Product/Process Change Notice (PCN)

PCN Number: PCN_UtPPTI_20250714

Affected Series: WE-PPTI

Affected Part Number: 760390012, 760390013, 760390013S

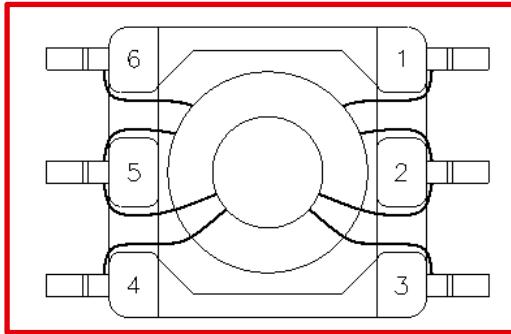
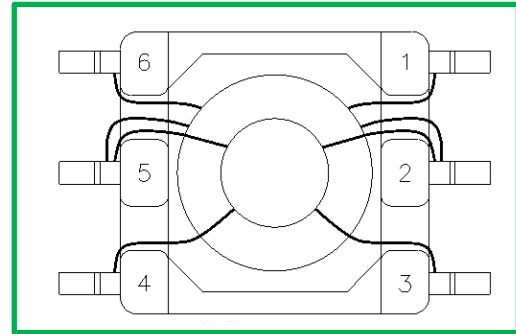
Due to an improvement of the production capability, Würth Elektronik will change the wire routing on the above listed parts. This will provide more consistent wire terminations by allowing the wire stripping and termination process to be automated.

The wire routing will change as shown. See before change in red and after change in green below.

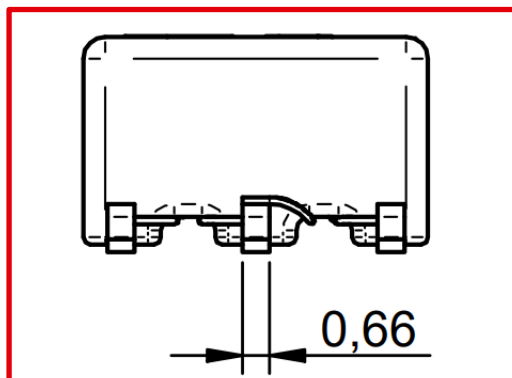
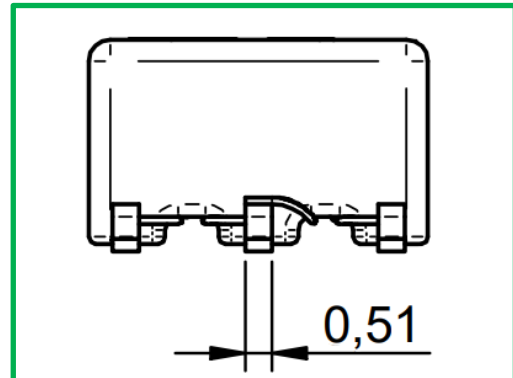
Also as a datasheet information amendment, Würth Elektronik will be correcting the pin width on our datasheets for the above listed parts. This is a datasheet change only.

The pin width on the datasheets will also change. See before change in red and after change in green.
